**Your Ref:** P/2015/0180

**Re UPPER PICKHILL (PLAS FRON)- ADDITIONAL INFORMATION**

PLAS FROM BARNS  
P/2015/0180

STANDARD DOOR DETAIL

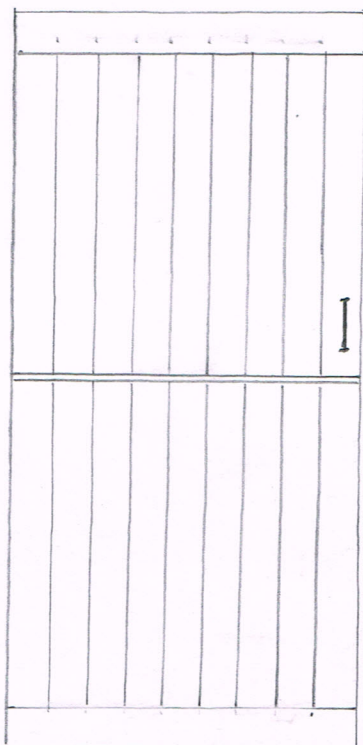
The applicant is now proposing that all standard sized external will be stable door type, please see enclosed sketch.

PURPOSE MADE TIMBER

STABLE DOOR

LARGE DOOR DETAIL

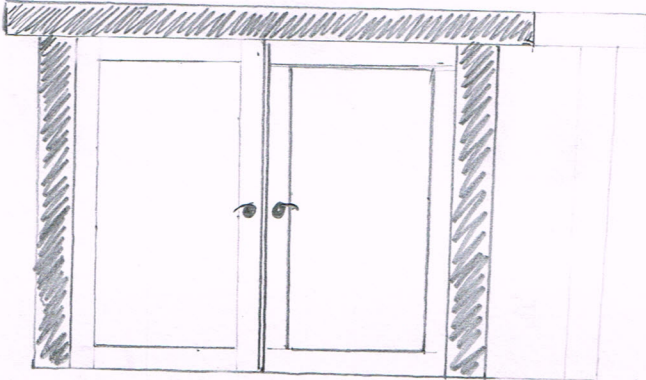
- a) Unit 2: D7 and D9- the applicant proposes to maintain the nature of the openings by framing with timber and reducing the size of the doors- see enclosed sketch. The alternative suggestion would be to remove the glazing bars, although glazing bars were originally included to be in keeping with existing.
- b) Unit 3: D6- as above.
- c) Unit 4: D1, W1, W2, W3, D11, W8- D1 as above; W1, W2, W3 replicate existing as closely as possible and are mirrored in W6 and W7. The applicant wishes to leave these as proposed. W8 will be amended to a four pane window so that the panes are in keeping with the other windows to this building.

PURPOSE MADE TIMBER  
FRENCH DOOR

D7, D9 - UNIT 2
